BWI CONLE/FIXET RNAV SIDs (Departures)

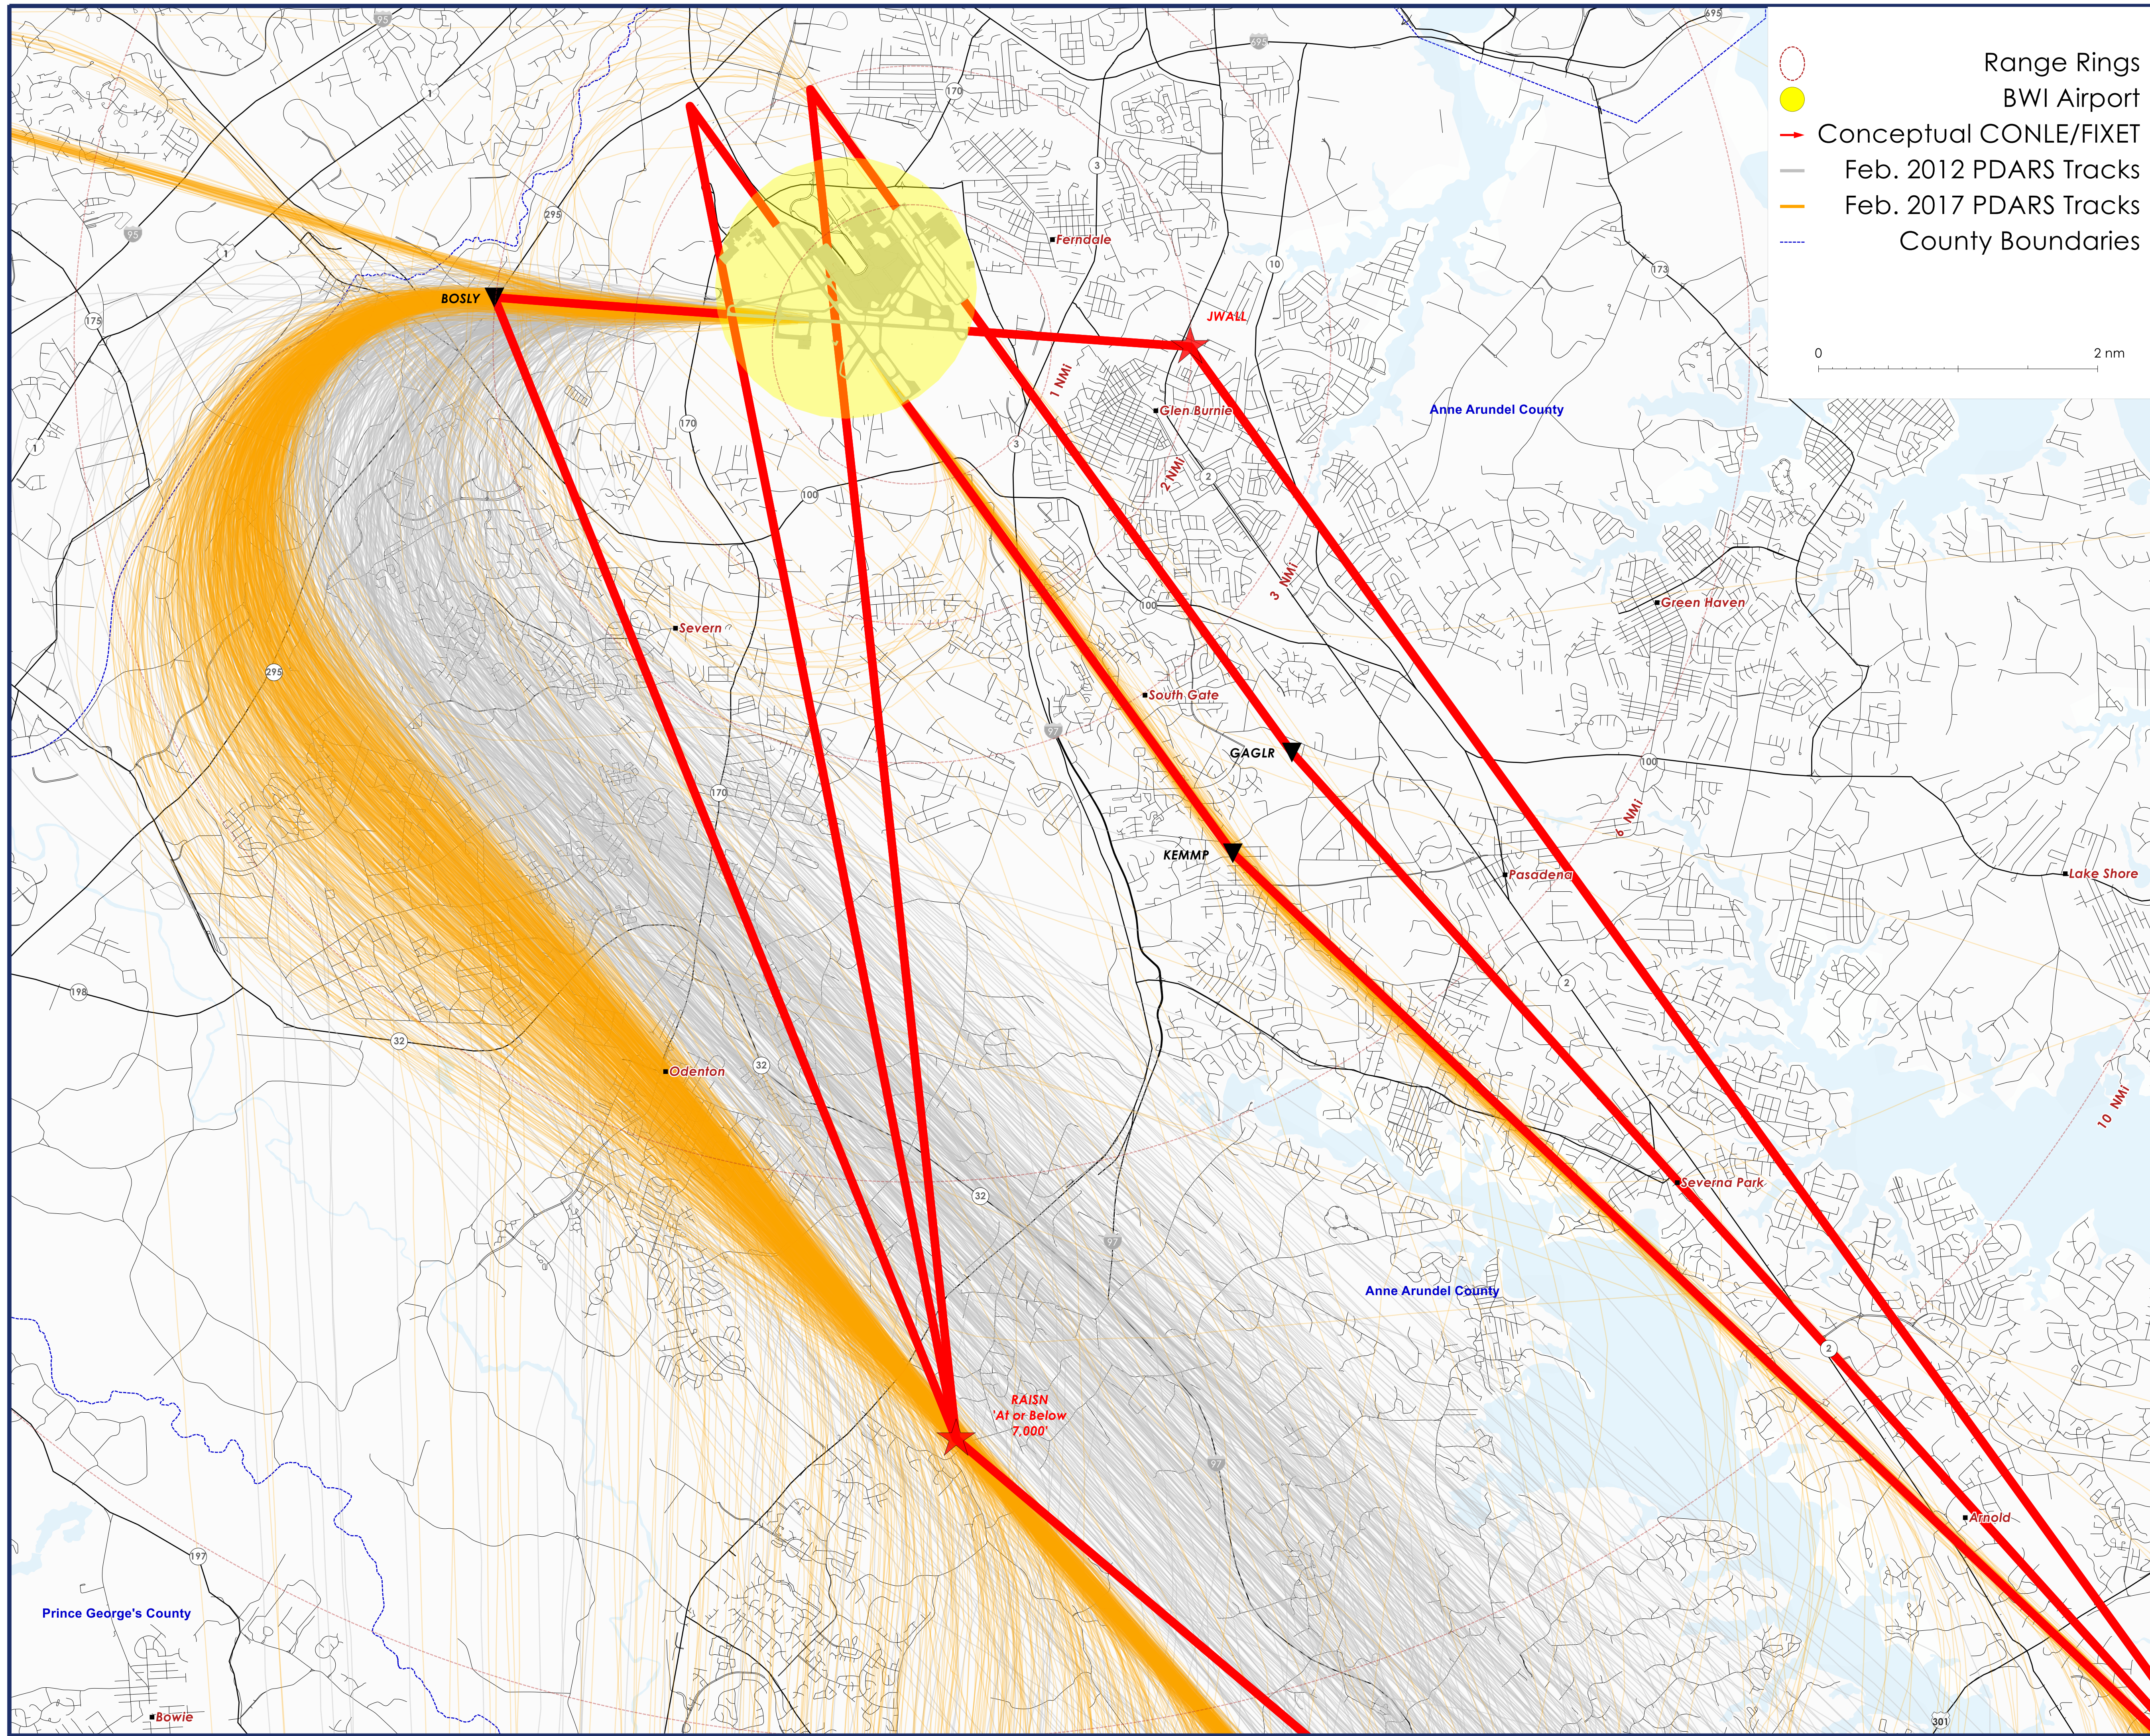
- No changes to departures off RWY 15L/R
- RWY 28 & 33L/R Changes:
 - Altitude restriction 'At or Below 7,000' ft added at RAISN for climb via clearance
- Runway 10 Changes:
 - JWall added 1 nm from end of RWY 10 for conformance with voluntary noise abatement plan and to utilize climb via
